# Access Compliance Report

## Public Rights-of-Way

Intersection ID: 45694	Main Street: E_ARROWOOD_RD	Cross Street: SILVER_ARROW_DR	Location: SE
ADA ID: BAD13308C20A	Ramp Type: PerpDiag	Initial Pass/Fail: Fail	Overall Compliance: No
Severity Score: 21.25			
Codes/Mitigation Info/Possible Solution		Field Measurements/Component Compliance

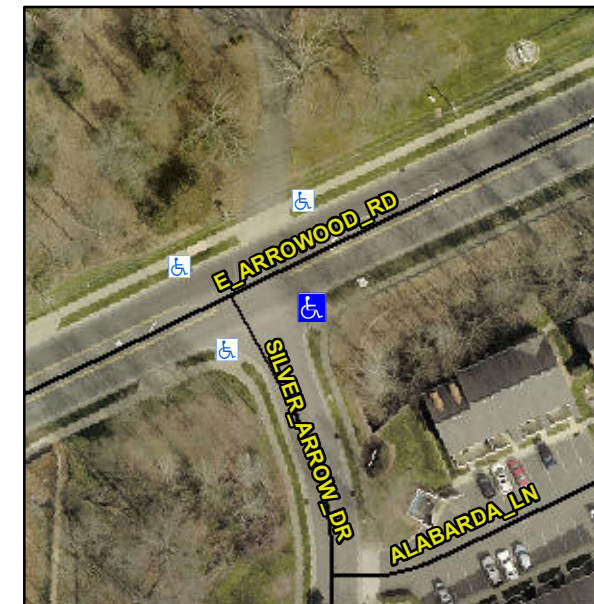
**Remove & Replace Curb Ramp With Two New Directional Ramps or Equivalent.**

**Not Found, R304.5.1, R304.2.2**
